In re Application of  
Frank D. Husson, Jr.  
Application No. 10/039,277

Atty. Dkt. No. SOLAR1120-3  
(051264-0306)

AMENDMENTS TO THE DRAWINGS

FIG. 1 (A)

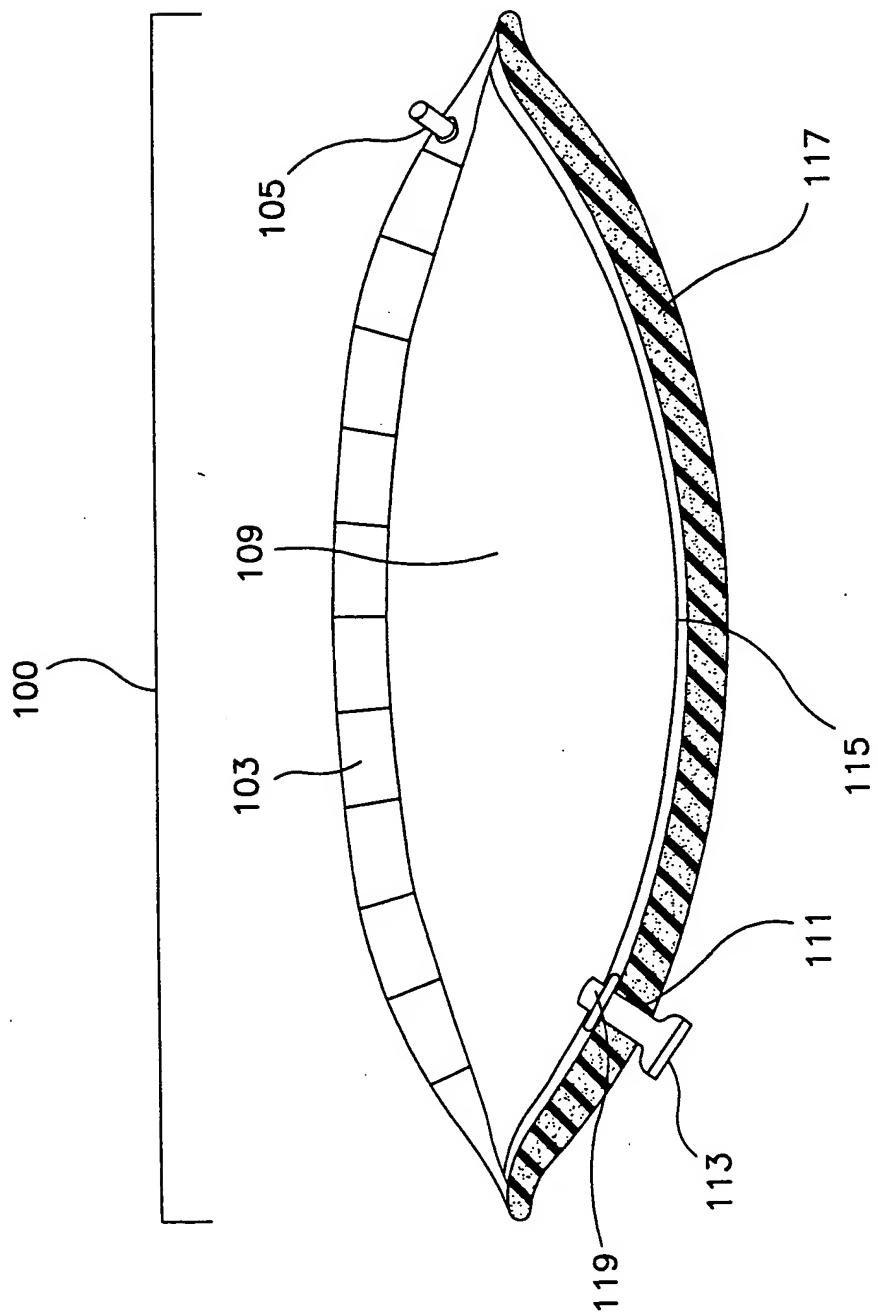
Attached Exhibits 1 and 2 include amendments to the drawings including changes to FIG. 1. Specifically, FIGS. 1(A) and 1(B) replace the original FIG. 1. In FIG. 1(B), previously un-illustrated element **121** has been added. Exhibit 1 includes annotated copies of FIGS. 1(A) and 1(B). Exhibit 2 includes replacement sheets for FIGS. 1(A) and 1(B).

FIG. 1 (B)

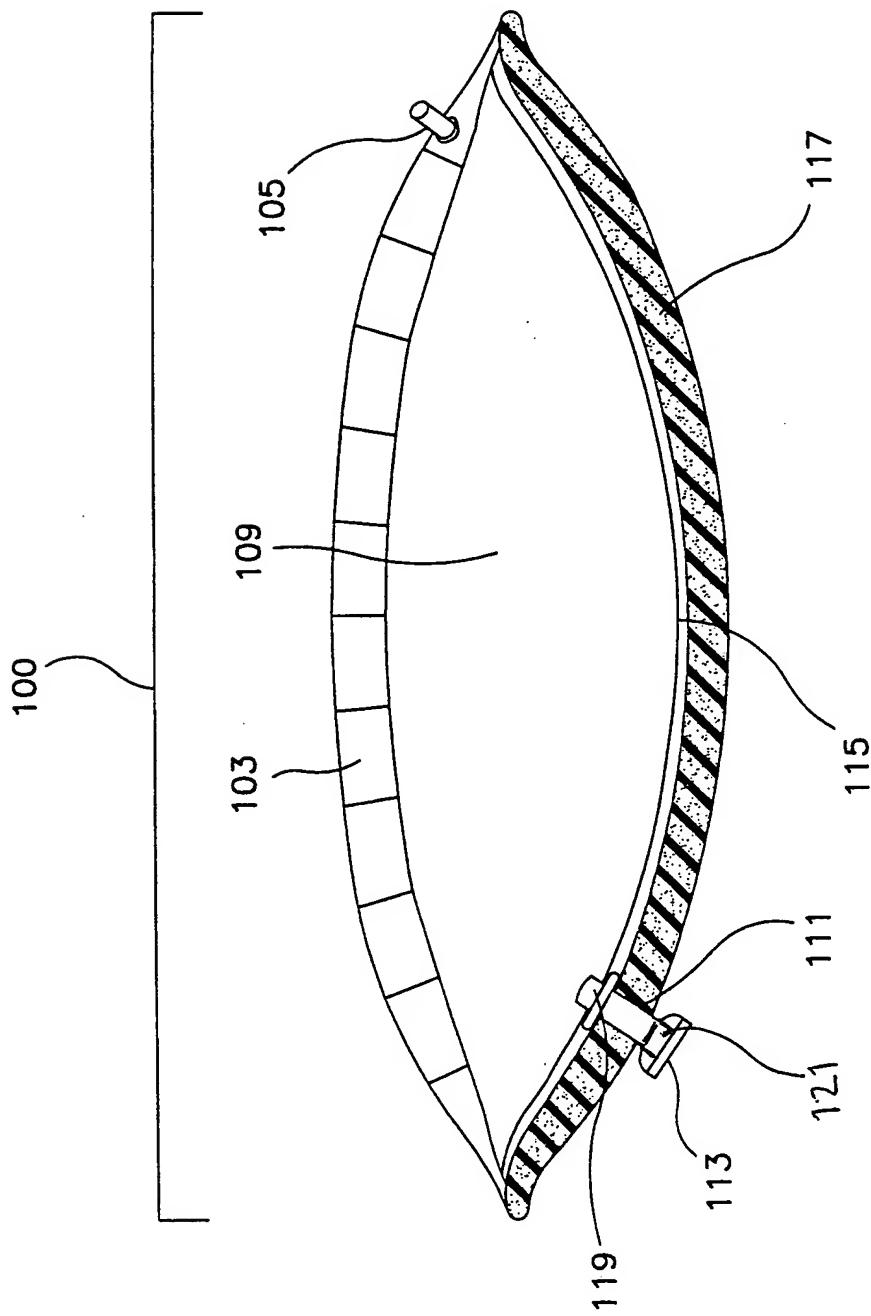
However, in order to reduce the issues and expedite the prosecution of this application, FIG. 1 has been amended. Specifically, bracket (121) has been added to FIG. 1(B) to reflect all the features of claim 1. Paragraph [0062] of the specification has been amended to reflect the amendment of FIG. 1. Support for these amendments is found at page 15, lines 5-9 of the original specification wherein it states:
